REGIONAL REVIEW FINDING

ARC REVIEW CODE: R1001271

Name of Proposal: Coffee Road MRF

SUBJECT: **TPD Review of DRI # 2086**

1. THE RACK ELEMENT

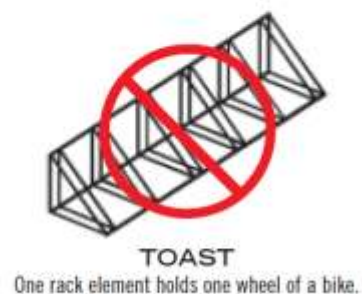
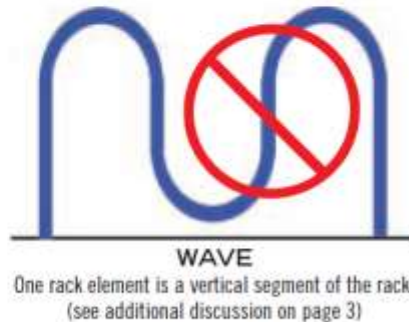
The bicycle rack is identified on the site plan, and should be installed in accordance with best practices. APBP Bicycle Parking guidelines are suggested, as illustrated in the figure below:

The rack element should:

- Support the bicycle upright by its frame in two places
- Prevent the wheel of the bicycle from tipping over
- Enable the frame and one or both wheels to be secured
- Support bicycles without a diamond-shaped frame with a horizontal top tube (e.g. a mixte frame)
- Allow front-in parking: a U-lock should be able to lock the front wheel and the down tube of an upright bicycle
- Allow back-in parking: a U-lock should be able to lock the rear wheel and seat tube of the bicycle

Comb, toast, school-yard, and other wheel-bending racks that provide no support for the bicycle frame are NOT recommended.

The rack element should resist being cut or detached using common hand tools, especially those that can be concealed in a backpack. Such tools include bolt cutters, pipe cutters, wrenches, and pry bars.
